HISTORIC AND DESIGN REVIEW COMMISSION

August 21, 2024

HDRC CASE NO: 2024-292
ADDRESS: 901 N ALAMO ST
LEGAL DESCRIPTION: NCB 454 BLK 32 LOT 9, 10 & 11
ZONING: FBZ T6-1, H
CITY COUNCIL DIST.: 1
DISTRICT: Alamo Plaza Historic District
APPLICANT: Hue Nguyen/901 NORTH ALAMO LLC
OWNER: Hue Nguyen/901 NORTH ALAMO LLC
TYPE OF WORK: Exterior alterations
APPLICATION RECEIVED: July 30, 2024
60-DAY REVIEW: September 28, 2024
CASE MANAGER: Rachel Rettaliata

1. Remove and reconstruct the 2-story front porch. This includes incorporating an existing portion of enclosed porch and extending beyond the porch footprint to the south.
2. Replace the existing stucco cladding with Hardie siding.
3. Construct a 1-story rear addition.

1 NORTHWEST ELEVATION
SCALE: 3/16" = 1'-0"

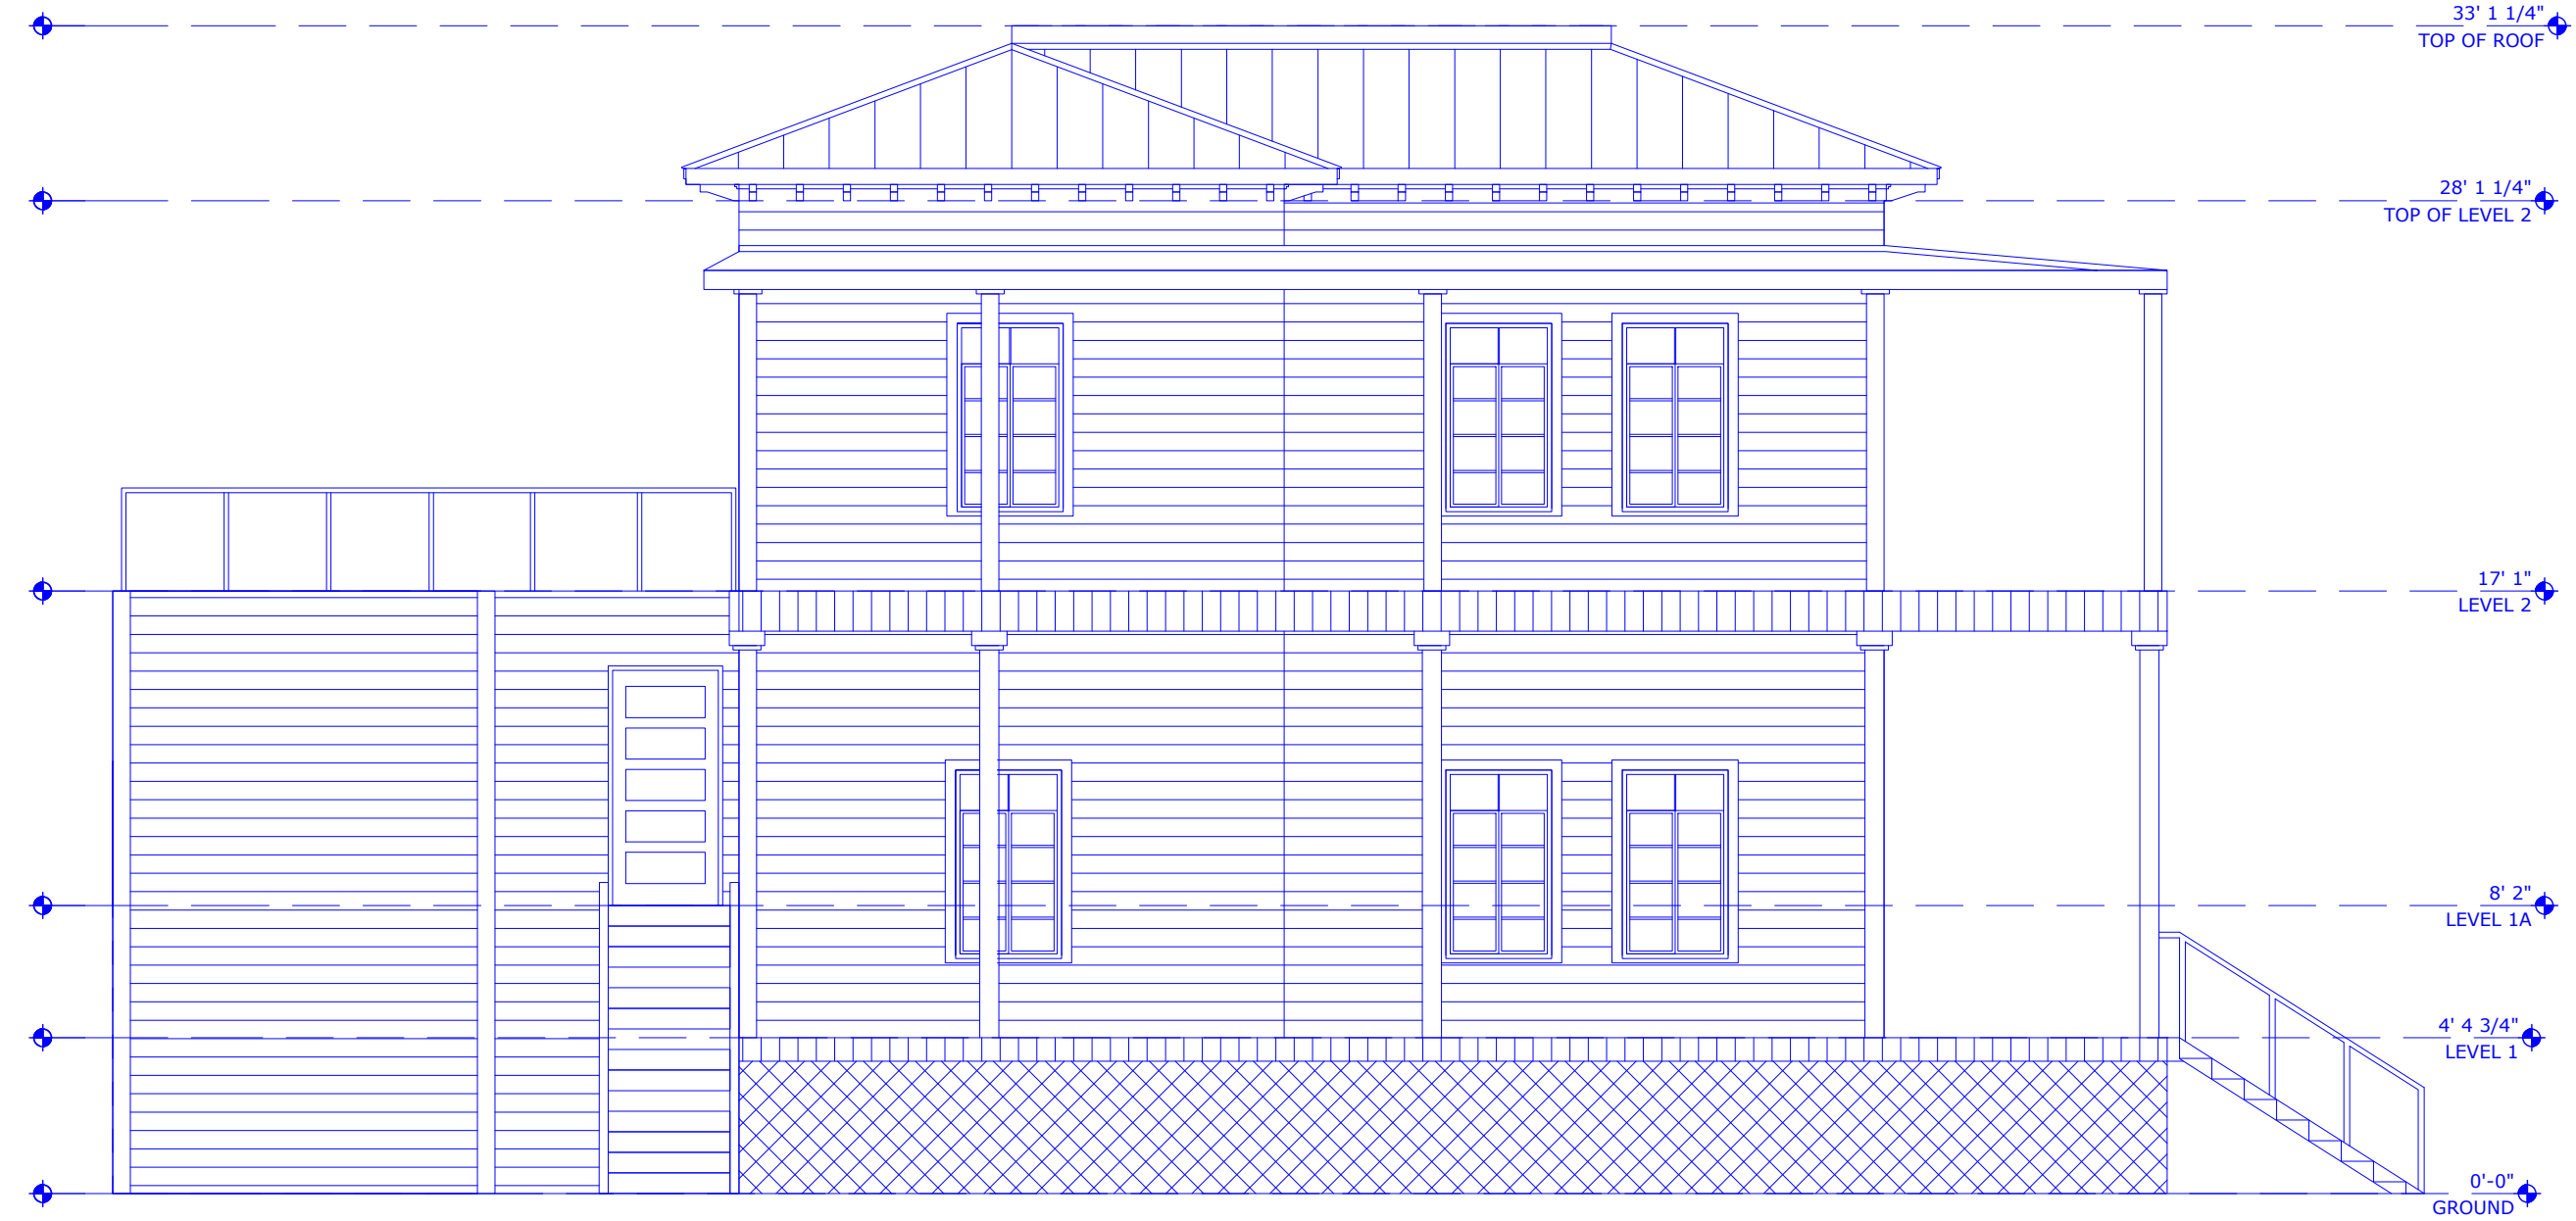
- b. FRONT PORCH MODIFICATION – The applicant has proposed to remove and reconstruct the 2-story front porch but has proposed to extend the side porch past the original porch footprint to add a side porch addition to the south of the existing side porch infill. The applicant has proposed to construct the front porch with a standing seam metal roof to match the existing roof form and 6"x6" wood columns. Per the 1888 Sanborn Map, the structure originally featured a full-width front porch and a separate side porch. By 1904, the Sanborn Map shows that the porch had been converted into a wraparound porch. In the 1940s, a number of metal commercial awnings and commercial additions were installed on the property. Currently, the side porch is infilled. Guideline 7.B.v for Exterior Maintenance and Alterations states that porches, balconies, and porte-cocheres should be reconstructed based on accurate evidence of the original, such as photographs. If no such evidence exists, the design should be based on the architectural style of the building and historic patterns. Staff finds the front porch removal and reconstruction appropriate but finds that the new front porch should match the original footprint, that materials such as porch decking, columns, and beadboard should be salvaged and reused where possible, and that the applicant should install classical columns to match the existing porch columns on the second story. The applicant should submit updated drawings and material specifications to staff for review.

- c. CLADDING REPLACEMENT – The applicant has proposed to replace the existing stucco cladding on the primary historic structure with Hardie siding. Guideline 1.B.i for Exterior Maintenance and Alterations states that applicants should consider exposing original wood siding if it is currently covered with vinyl or aluminum siding, stucco, or other materials that have not achieved historic significance. Additionally, Guideline 1.B.ii for Exterior Maintenance and Alterations states that applicants should use in-kind materials when possible or materials similar in size, scale, and character when exterior woodwork is beyond repair. Ensure replacement siding is installed to match the original pattern, including exposures. Do not introduce modern materials that can accelerate and hide deterioration of historic materials. Hardiboard and other cementitious materials are not recommended. Staff finds that exposing any original siding that is currently installed beneath the existing stucco or installing replacement fully wood siding in a traditional profile is more appropriate than the installation of Hardie siding.

- ii. That salvageable materials such as porch decking, columns, and beadboard, should be salvaged and reused where possible. The applicant is required to submit a salvage and reuse plan to staff for review and approval prior to the issuance of a Certificate of Appropriateness.

- iii. That the applicant installs classical columns to match the style of the existing second-story columns. The applicant should submit updated drawings and material specifications to staff for review and approval prior to the issuance of a Certificate of Appropriateness.

- iv. That the applicant submits final material specifications for the roofing, decking, columns, skirting, steps, and handrails to staff for review and approval prior to the issuance of a Certificate of Appropriateness. The standing seam metal roof must feature panels that are 18 to 21 inches wide, seams that are 1 to 2 inches high, a crimped ridge seam, and match the current finish or a standard galvalume finish. Panels should be smooth without striation or corrugation. Ridges are to feature a double-munch or crimped ridge configuration; no vented ridge caps or end caps are allowed. All chimney, flue, and related existing roof details must be preserved. An inspection must be scheduled with OHP staff prior to the start of work to verify that the roofing material matches the approved specifications.

- i. That the applicant removes the existing stucco to expose any original wood siding installed beneath the existing stucco cladding or replaces the stucco cladding with fully wood siding in a traditional profile. The applicant is required to submit evidence of any wood siding that remains in place or updated material specifications for a fully wood replacement siding material to staff for review and approval prior to the issuance of a Certificate of Appropriateness.

NORTHWEST ELEVATION

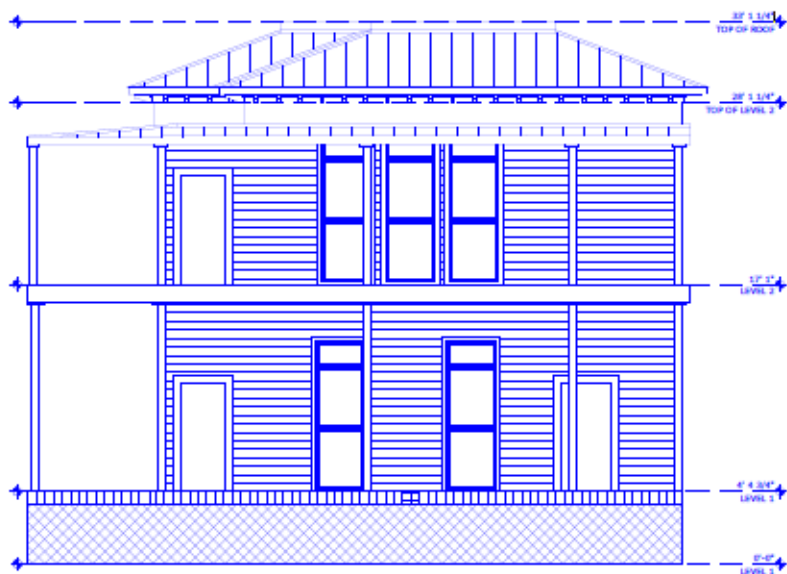
REQUEST: DEMO and REPLACE using pinewood and like-kind material. Finish shall be according to XS-1 on sheet A505 of construction set

SOUTHWEST ELEVATION

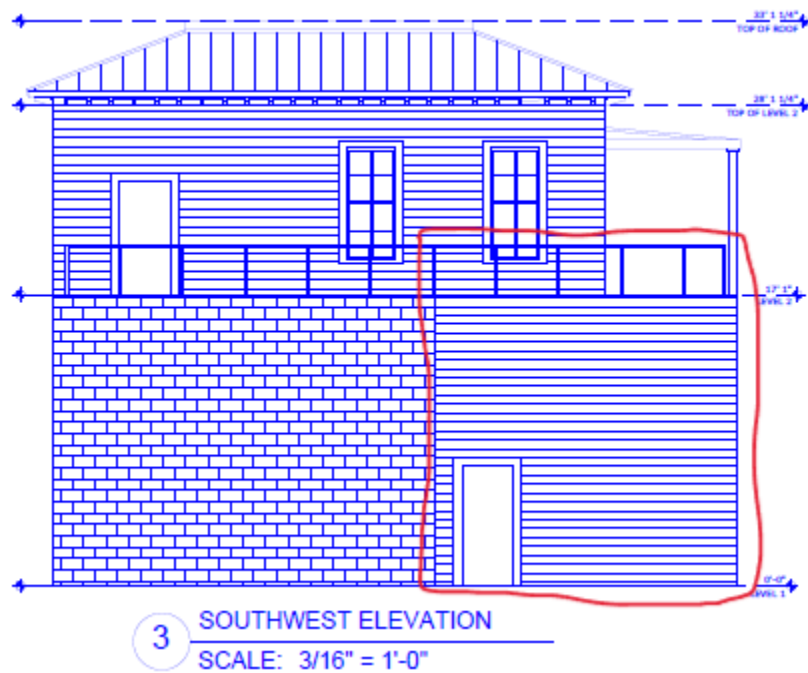
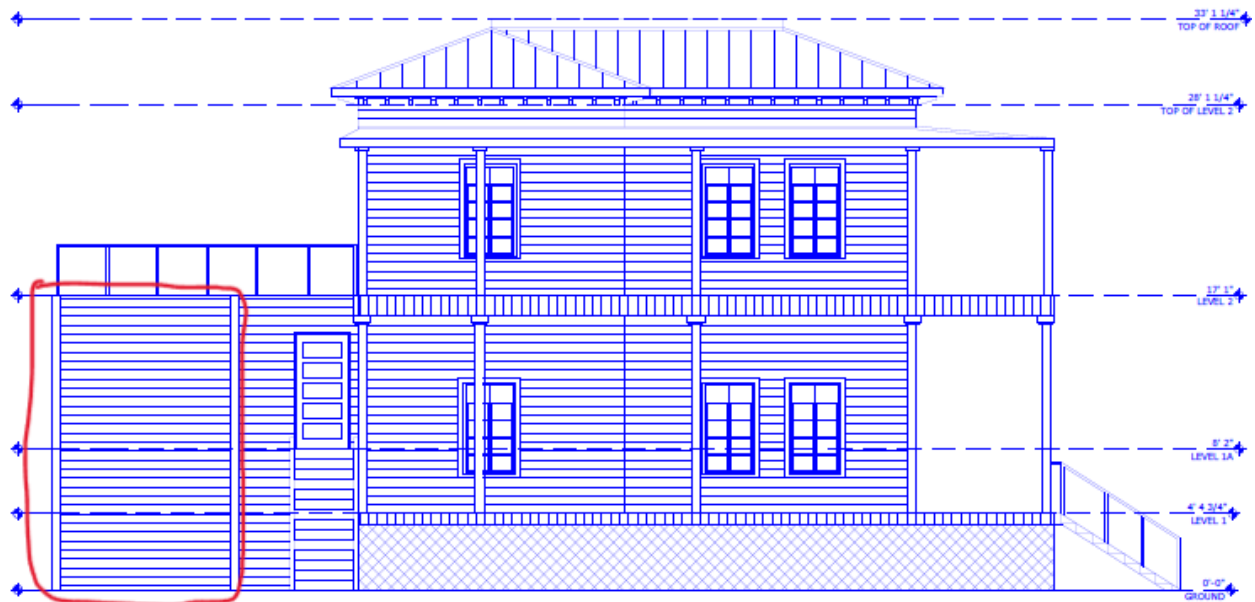
REQUEST: Demo and replace wooden shed are in the southwest part of the building with enclosed additions
